L4433A-02

S E R V I C E N O T E

L4433A Dual/Quad 4x8 Reed Matrix

Instrument cannot operate in 400 Hz

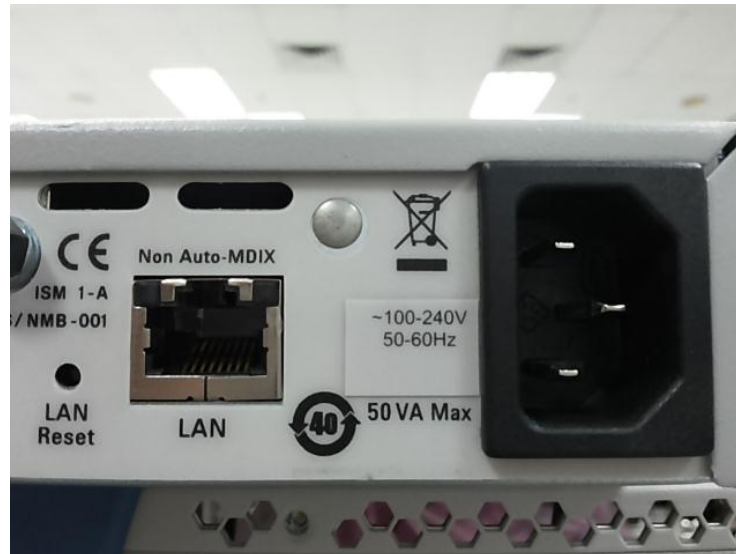
It has been found that the instruments with affected serial numbers listed above have incorrect information printed on the power rating label. The instrument does NOT support 400 Hz operation at 100-127V.

Order a L4421-84303 L44xxA Power Rating Label and apply it over the existing power rating information on the instrument. After applying the L4421-84303 label, it should look similar to the picture below.
